SAKURA EAST JSP25-09

Consideration of the request of Sakura Novi Residential LLC for Preliminary Site Plan and Storm Water Management Plan. The subject property is zoned TC-1 with a Planned Rezoning Overlay (PRO), which conditions development to the terms of a PRO Plan and Agreement. The applicant is proposing to develop 45 multifamily residential units.

PLAN REVIEW CENTER REPORT

WETLAND & WOODLAND REVIEW

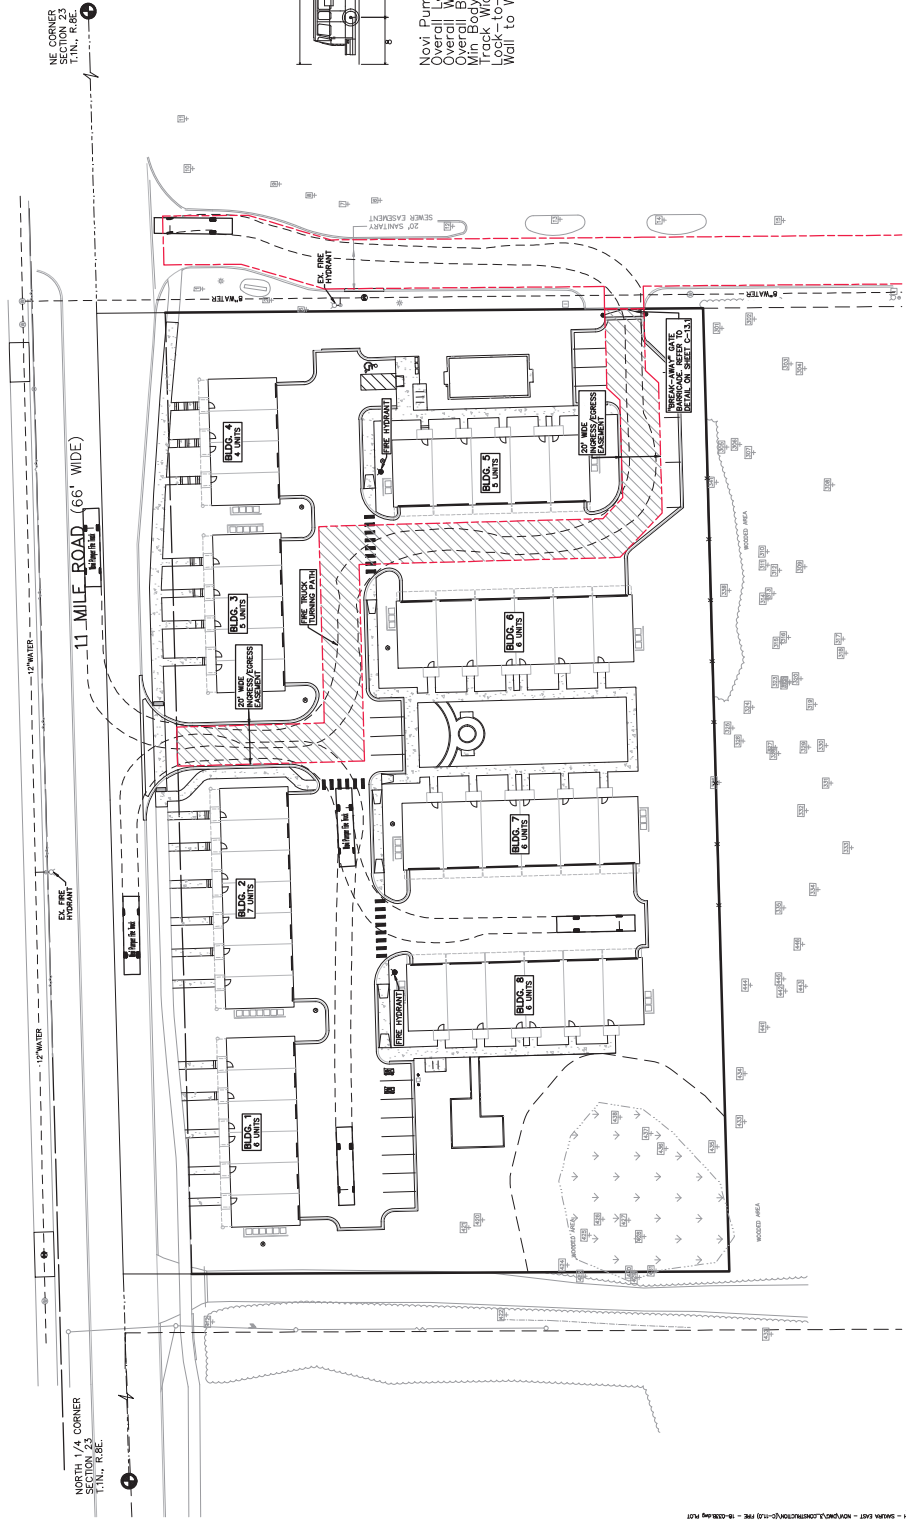
1. Fire Turning Radius: As noted in the Fire Review, the Sheet C-11.0 continues to model a 40-foot length emergency vehicle. **The correct truck length is 48'6", with a 50' outside swing radii. The Fire Truck spec is attached to the Fire Review. The turning radius issue needs to be resolved in order to confirm that the driveway width and other dimensions do not need to be modified, which could impact other elements of the layout.**

Figure 1. City of Novi Regulated Wetlands Map
 Approximate Site boundary is shown in red.
 (Approximate) Regulated Wetland areas are shown in turquoise.

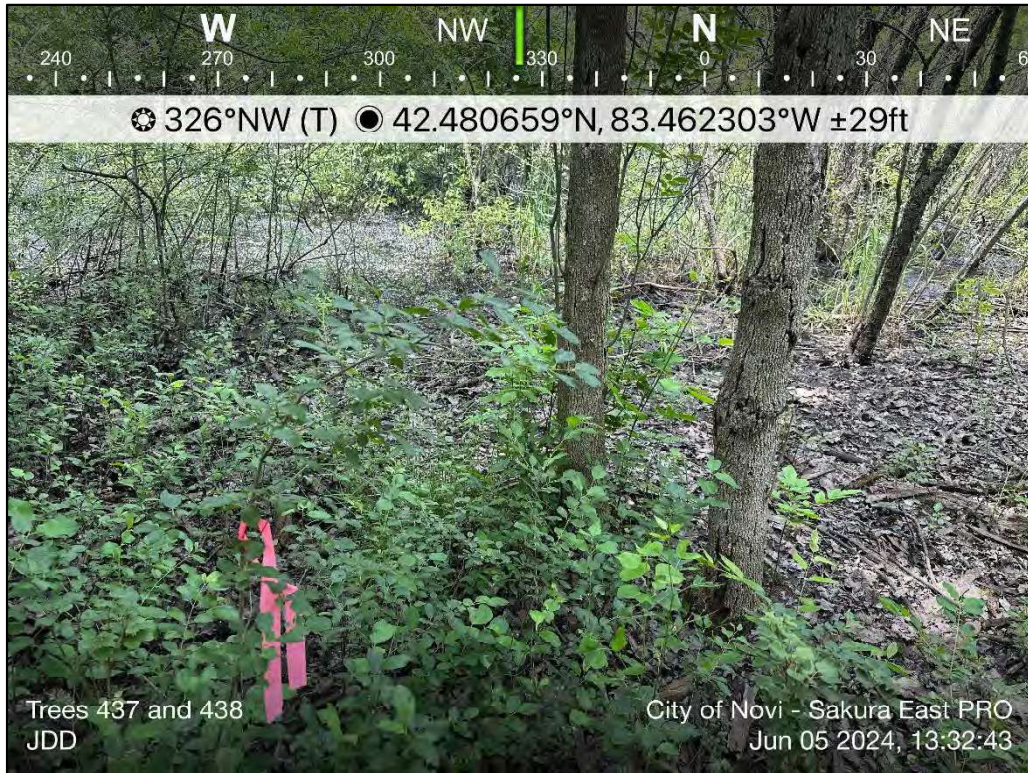
- ☒ City-regulated wetlands, as identified on the City of Novi interactive map website. Note that both wetland and property limits depicted on the City's map are considered approximations (**Figure 1**).

Attachment A
Site Photographs

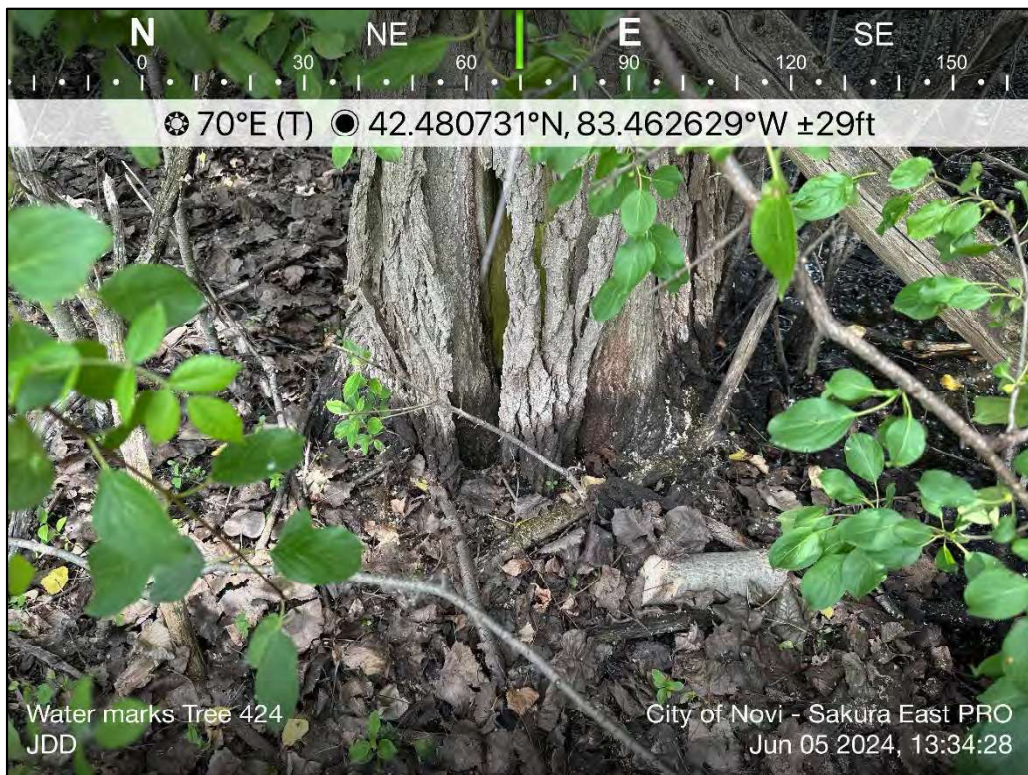
Overview of the southwestern portion of Wetland 1.

Overview of Trees 423 and 424. Note the pink flagging in the background behind the two trees.

Overview of Trees 436 and 437 with the adjusted pink flagging.

Water marks and water stained leaves around Tree 424 (primary indicators of wetland hydrology).
